AI_4_06 Grid Connection: Further Clarification

Glen Earrach Energy Pumped Storage Hydro (PSH) Project

Response to THC Planning Officer correspondence dated 31 July 2026

ECU Ref: ECU00005121

DRAWING TITLE: Glen Earrach OHL 60m Tower Indicative Viewshed (Viewshed Output 2m TH - Localised Visibility)

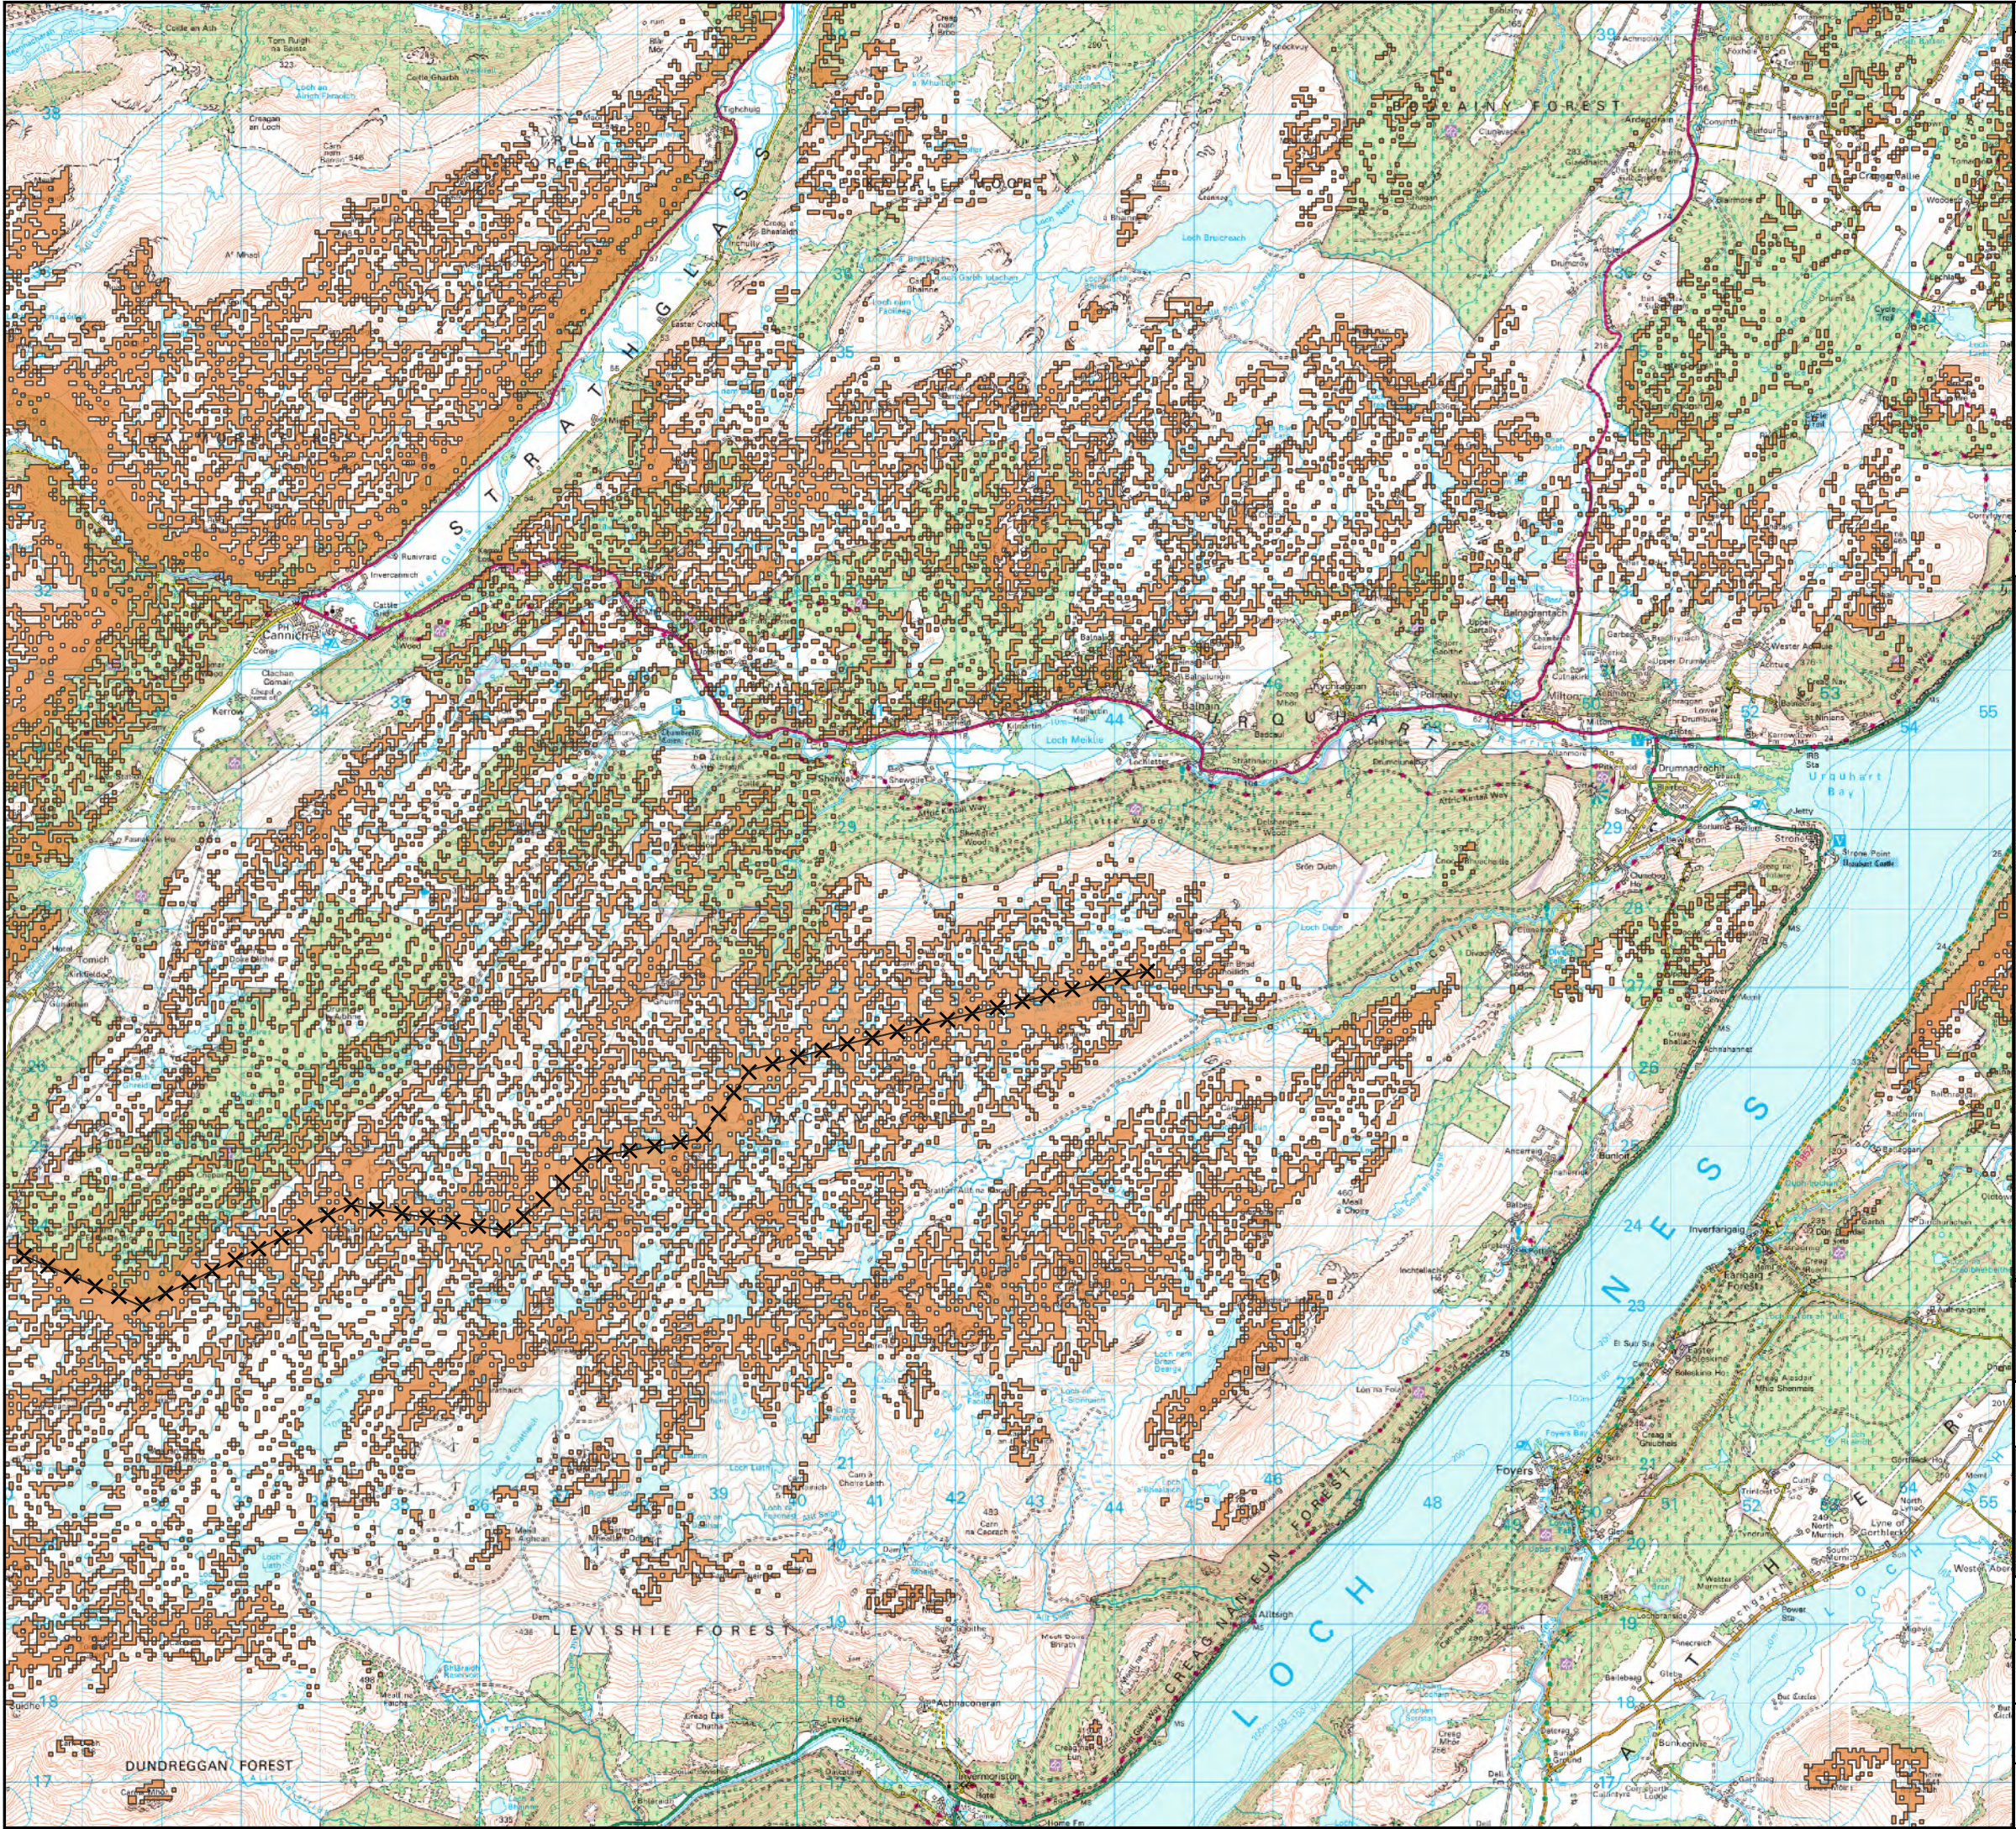
The Applicant has reviewed the correspondence from The Highland Council Planning Officer dated 31 July 2026, which sought further clarification regarding the indicative grid connection associated with the Proposed Development. The matters raised included the current level of definition of the indicative overhead line (OHL), potential tower parameters and visibility, the relationship with other proposed grid infrastructure in the area, and the availability of further landscape and visual information.

The resulting indicative viewshed is provided in the **Glen Earrach OHL 60m Tower Indicative Viewshed (Viewshed Output 2m TH - Localised Visibility)**. It identifies the theoretical geographical extent from which some part of a nominal 60 m tower could be visible on this deliberately conservative basis.

A formal ZTV of the future OHL connection has not been prepared because there is no defined OHL design or final tower schedule at this stage. The **Glen Earrach OHL 60m Tower Indicative Viewshed** drawing instead presents a deliberately conservative terrain-based viewshed using nominal 60 m illustrative tower positions and is provided to give additional context on potential visibility; it is not put forward as a ZTV of the final grid connection.
